Tennessee Valley Authority, Post Office Box 2000, Spring City, Tennessee 37381

WATTS BAR NUCLEAR PLANT (WBN) - FINAL SAFETY ANALYSIS REPORT (FSAR)
- PROPOSED CHANGES FOR AMENDMENT 90

The purpose of this letter is to provide draft FSAR pages to facilitate the NRC'S review of the FSAR. Enclosed are the marked-up pages, which will be included in Amendment 90 scheduled to be submitted by August 31, 1995. The marked-up pages include editorial and other changes resulting from TVA's continued review of the FSAR and from preoperational testing activities.

FIGURE 8.3-5a

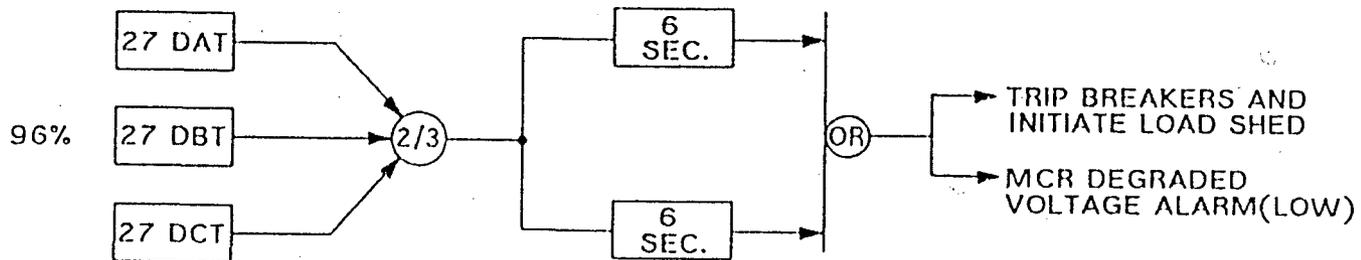
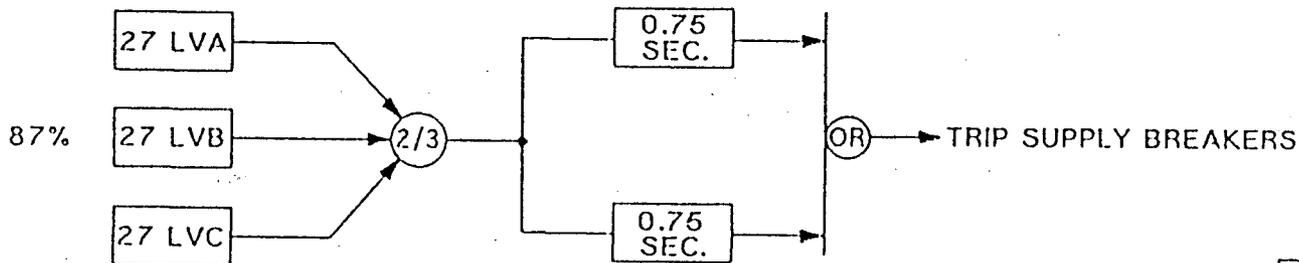
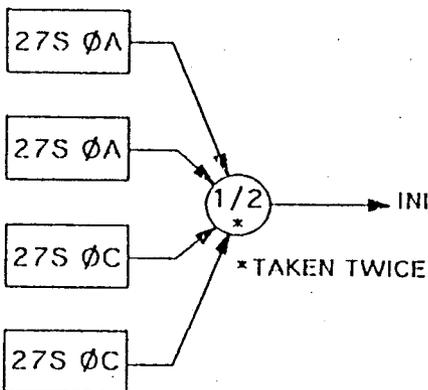
These relays are arranged in a two-out-of-three coincidence logic (Figure 8.3-5A) to initiate a 6-second (nominal) time delay. At the end of 6 seconds, if the voltage is still low, an alarm will be annunciated in the Control Room, a trip of the 6.9-kV shutdown-board supply breaker will occur, load-shedding from this board will be initiated, and the 480V shutdown-board current-limiting reactor-bypass breaker will close.

POWERHOUSE
 AUXILIARY, REACTOR & CONTROL BUILDING
 PLAN EL 755.0 & 757.0
 RADIATION ZONE MAP
 FSAR FIG 12.3-4

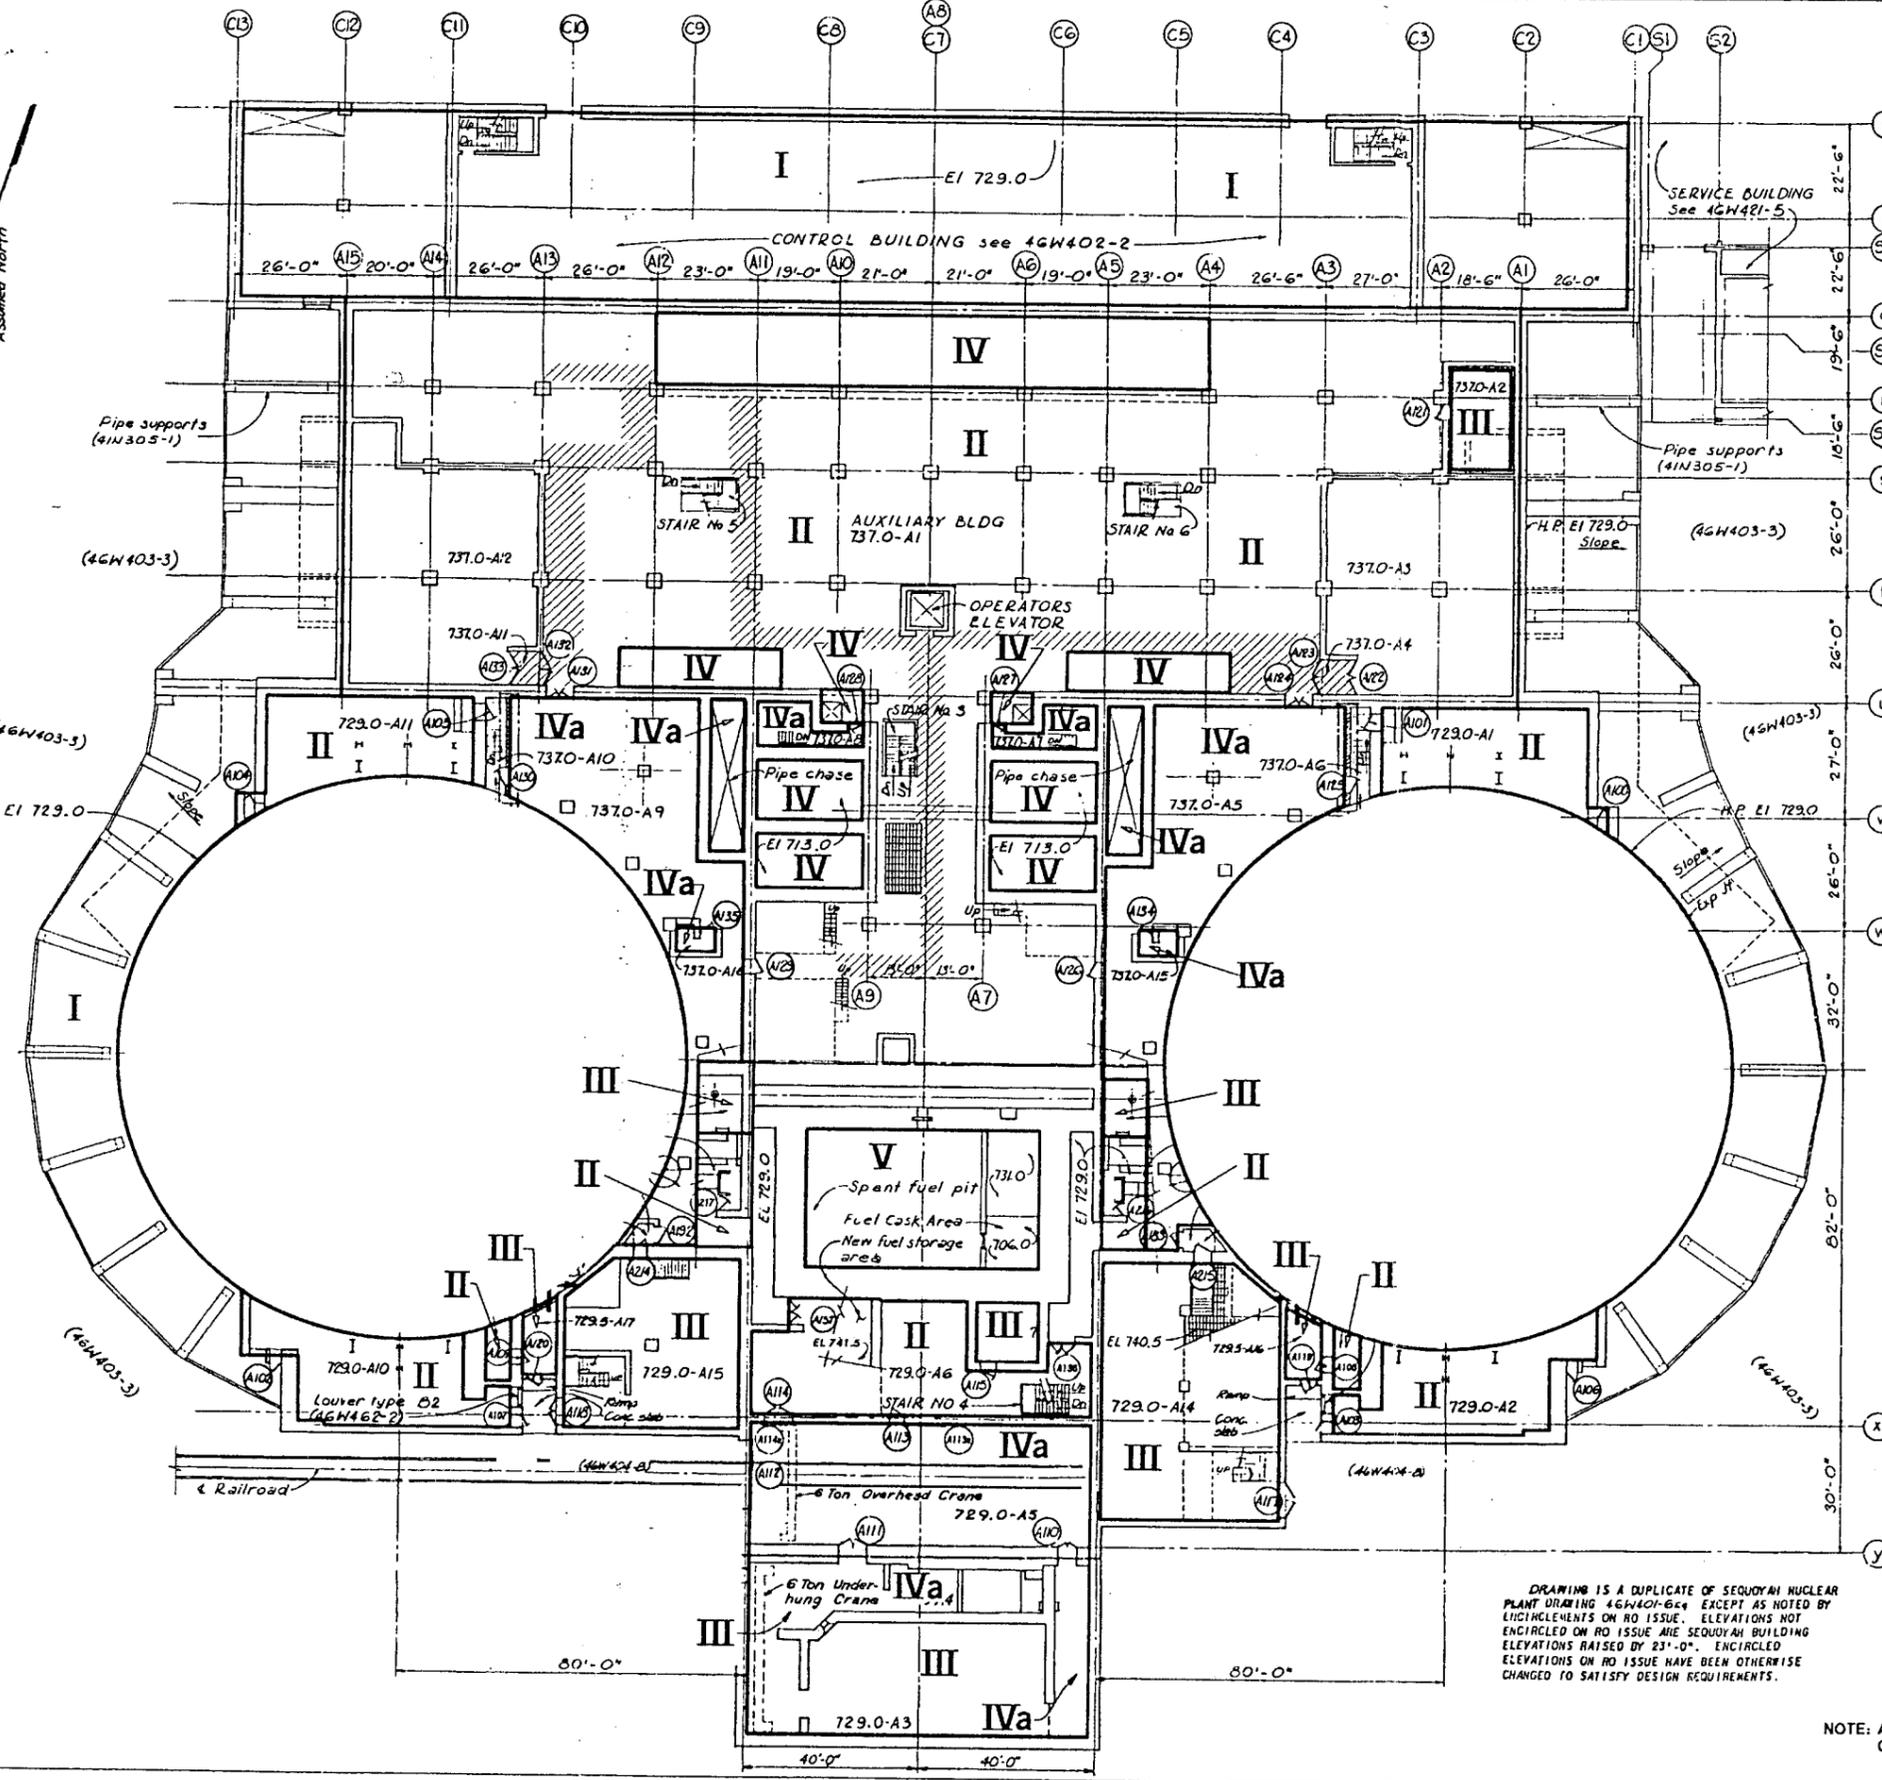
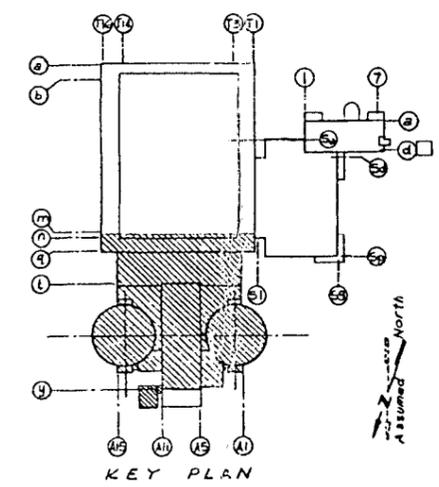
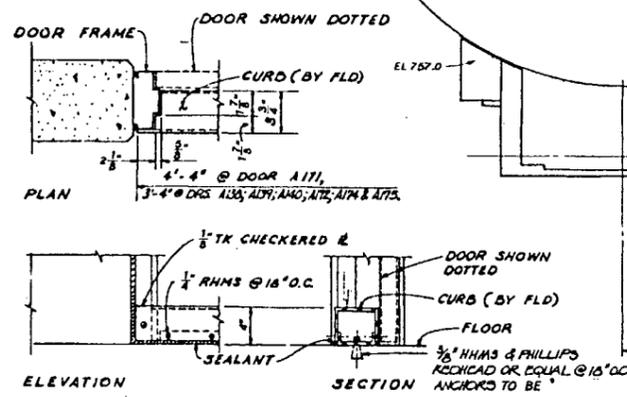
REVISED BY AMENDMENT X
